**RECORD OF DECISION**  
**Proposed I-75 Widening and Reconstruction from M-102 to M-59**  
**Oakland County, Michigan**

**FHWA-MI-EIS-03-01-F**

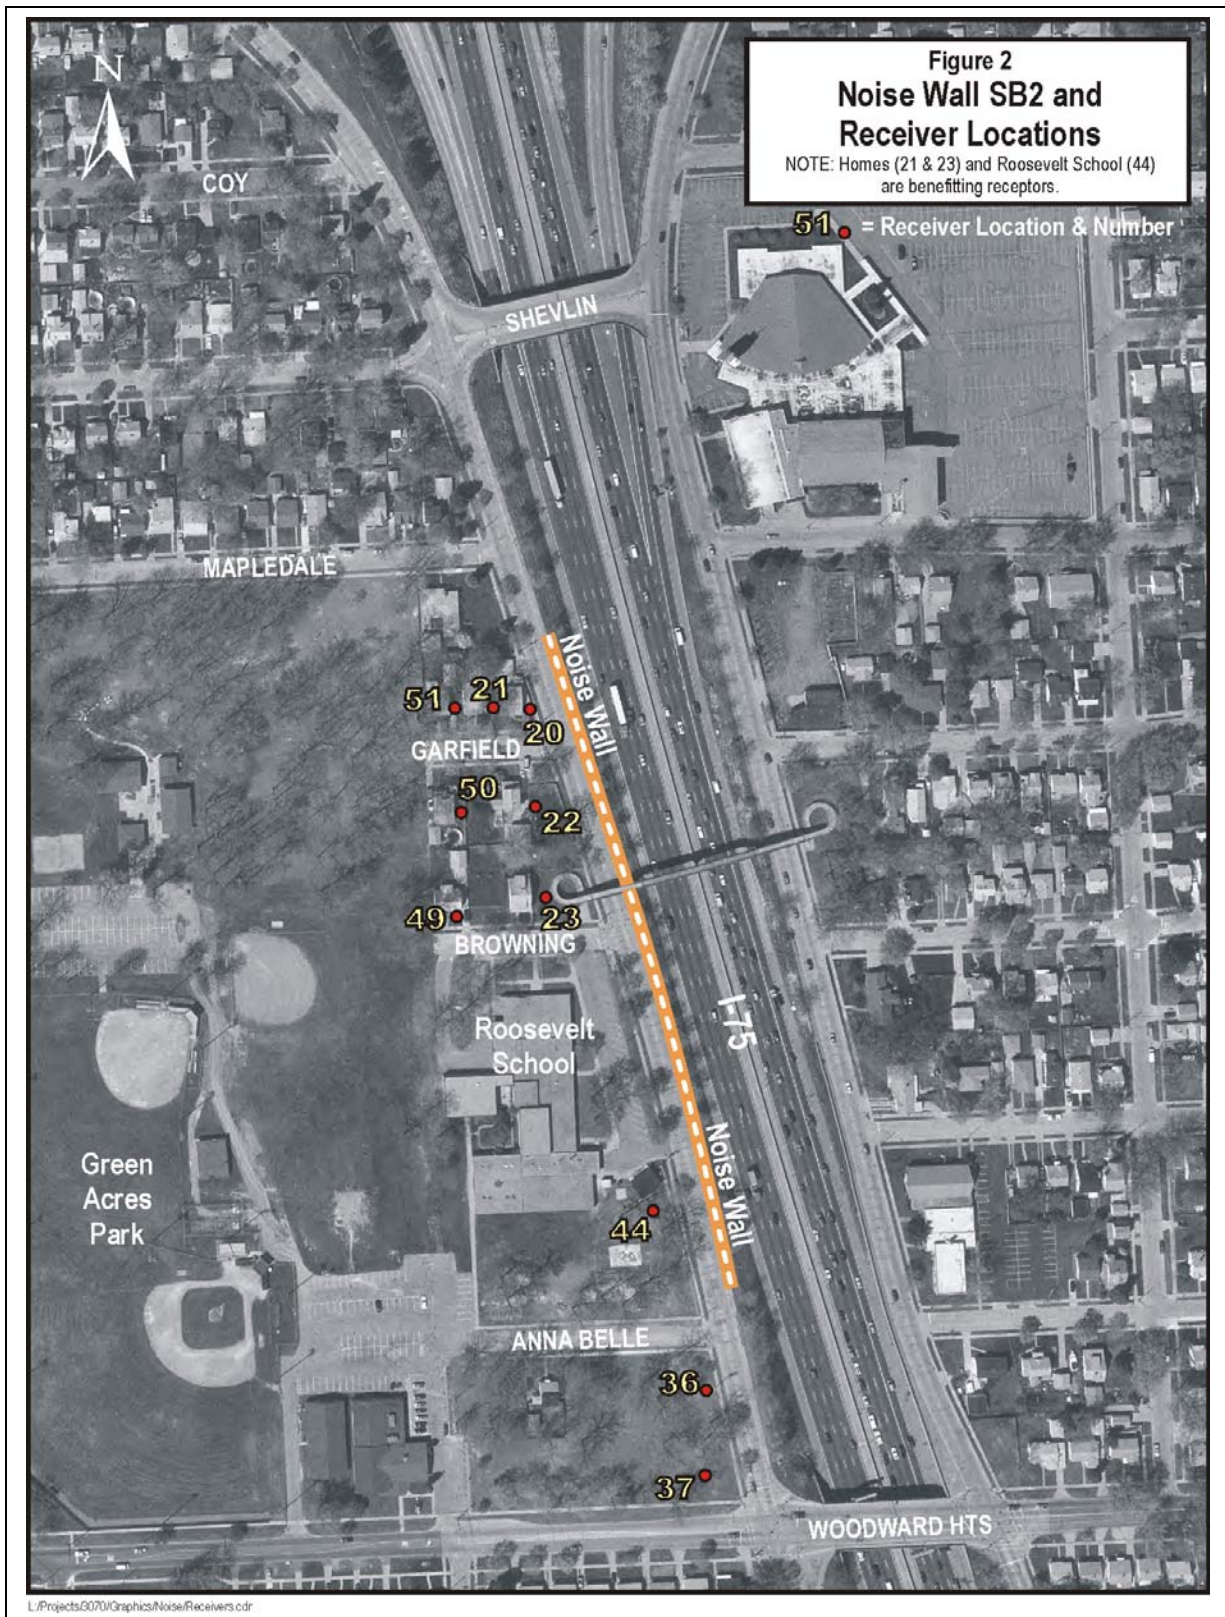
Comment: Comments were received from citizens at the public meeting of July 19, 2005 related to noise, and a letter was received from the City Manager of Hazel Park asking that a sound barrier wall be reevaluated between Woodward Heights and I-696, citing new home construction in the area.

Response: A reevaluation of the data and results in the southwest quadrant of I-696 and I-75 was undertaken and a reconfiguration of the FEIS noise wall was found reasonable and feasible. During the course of the study, elements of Michigan's Noise Policy were clarified. Churches and schools were given special status, but the method of calculating benefits changed over the course of the project. In the final analysis, churches and schools may be counted as the equivalent of 10 dwellings units in determining whether walls are reasonable and feasible. But to be counted in this manner, they must have an adjacent benefiting dwelling unit.

In the FEIS, wall SB2 was not considered reasonable and feasible. A review of the analysis found that by adjusting wall SB2, two homes north of the school can benefit, which allows the school to be counted as ten units. (Figure 2 shows the homes and the extent of the revised wall.) The homes are on the north side of West Garfield and north side of West Browning Avenue. The latter street separates the school from the residences to the north. Thus, wall SB2 is now considered reasonable and feasible.

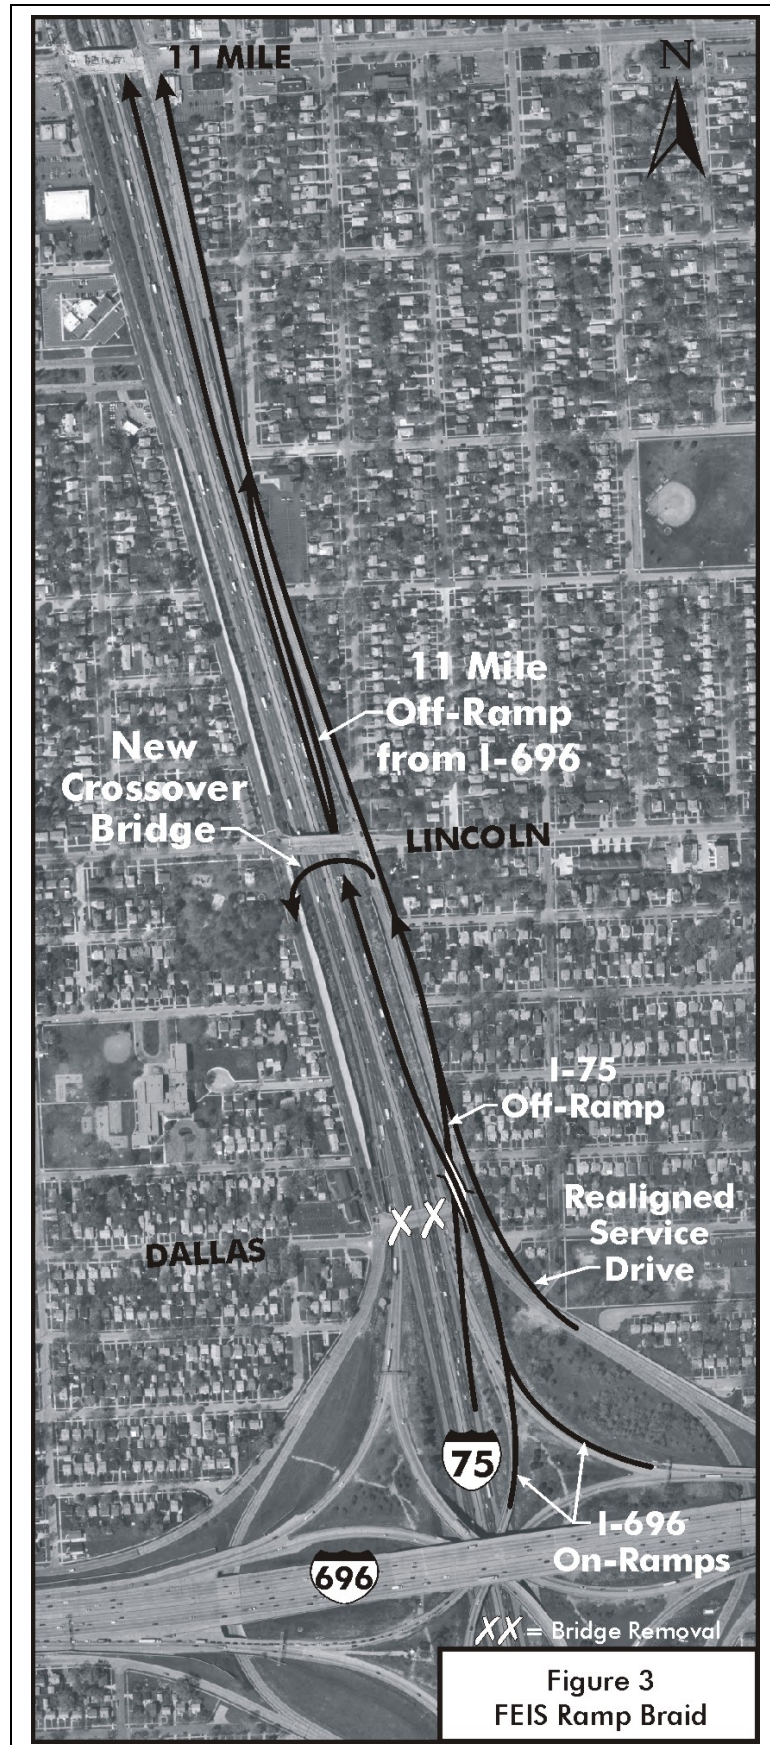
Comment: A city of Royal Oak resolution dated August 1, 2005, states, "Therefore, be it resolved that the City of Royal Oak wishes to reserve the option of not having the Lincoln Bridge rebuilt amongst other possible considerations." Two letters, four emails, and 39 opposition forms were submitted, principally by those living on, or near, Lincoln Avenue in Royal Oak. The Oakland County Board of Commissioners adopted Resolution #05148, August 18, 2005, recommending that MDOT "address and mitigate the effect of additional traffic on Lincoln in the possible design of the Lincoln Road exit."

Response: These comments are based on a concern that the revised FEIS braid design (Figure 3) will increase westbound traffic on Lincoln Avenue in Royal Oak. Braiding the I-75 northbound off ramp and I-696 on ramps to prevent conflicts in the resulting weave area was found to be the single most important component to travel flow and safety of the Selected Alternative. Of the 18 one-way project miles, this section of I-75 has the third highest crash rate of any section between M-102 and M-59, and the section to the south has the second highest crash rate.
